ADDENDUM NO. 1

April 13, 2026

DEXTER MUNICIPAL AIRPORT
Replace Runway 18/36 Lighting
Project No. 26-076A-1

E-202

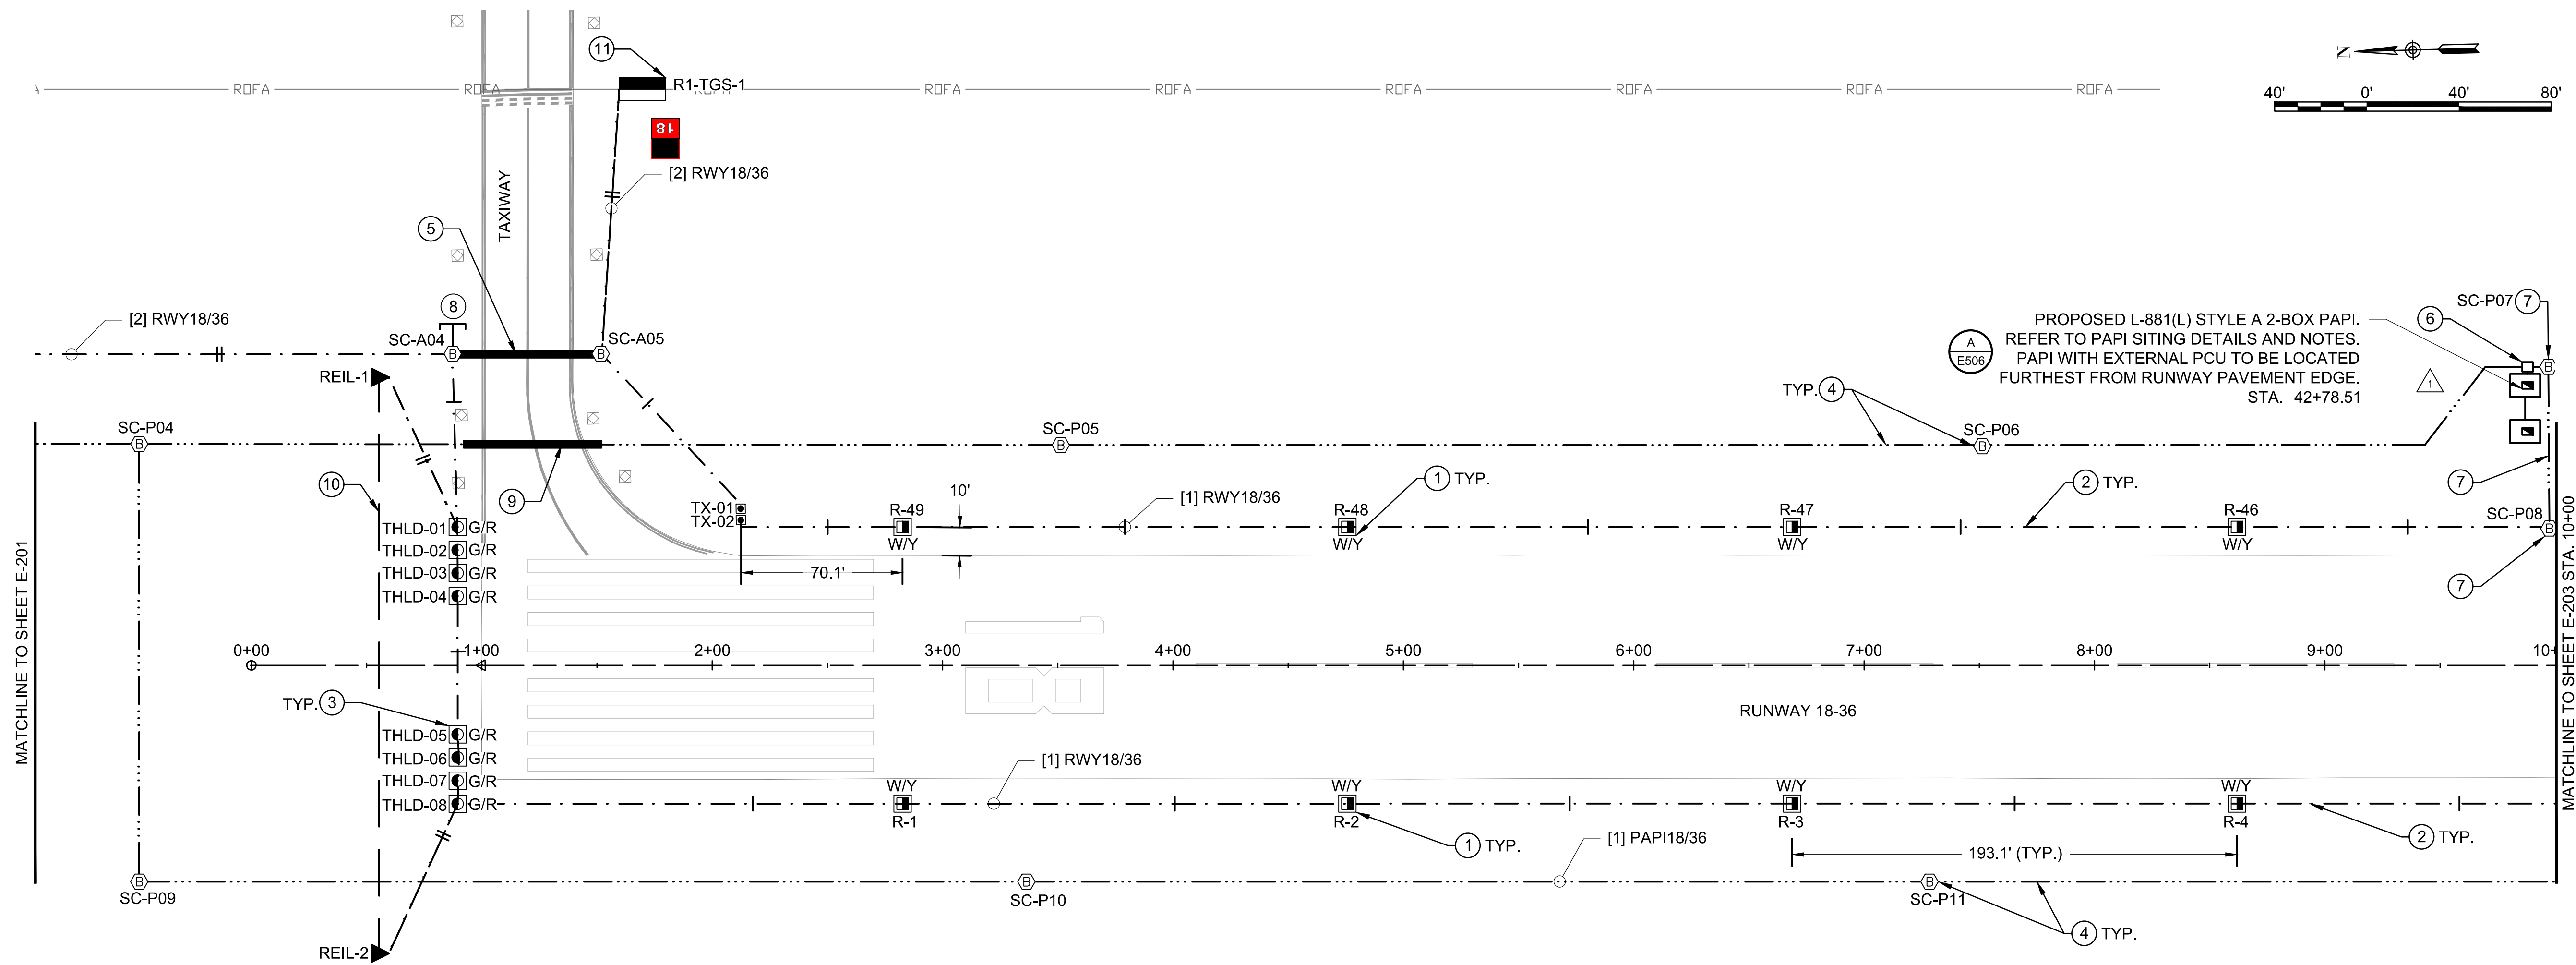
- Delete:** Plan Sheet E-202, issued March 27, 2026.
Insert: Plan Sheet E-202, revised April 13, 2026 (attached).
Revise: The configuration of the PAPI pads is revised.
